Product Change Notification

INDUCTIVE COMPONENTS

November, 2009

Change in Width, Thickness, Coating and Marking for EMI Model -T

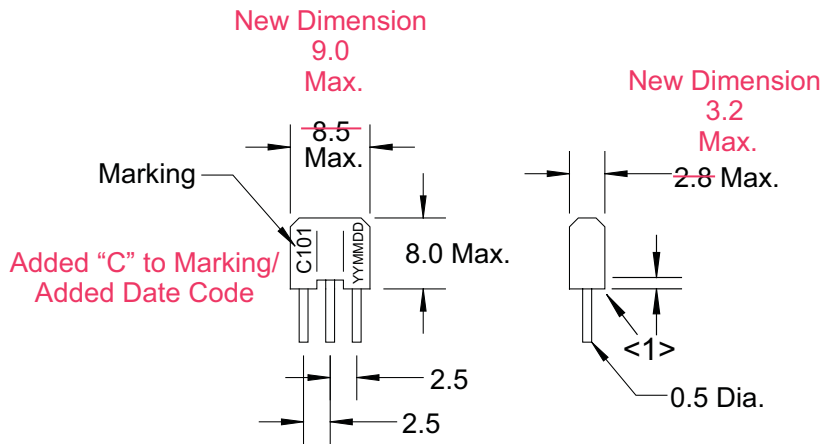
Effective immediately, the following changes will be made to the [EMI Model – T network filter](#):

Width: 9.0 mm max. (previously 8.5 mm max.)

Thickness: 3.2 mm max. (previously 2.8 mm max.)

The larger dimensions are the result of epoxy double-dipping to fully coat the components, minimizing the occurrence of pin-holes.

Bead Exposure: Up to 1 mm (previously up to 0.75 mm)

Marking: Component identification and date code will be added.

~~<1> Beads exposure <0.75 mm (0.030 ")~~

New Dimension <1> Beads exposure <1 mm (0.039 ")
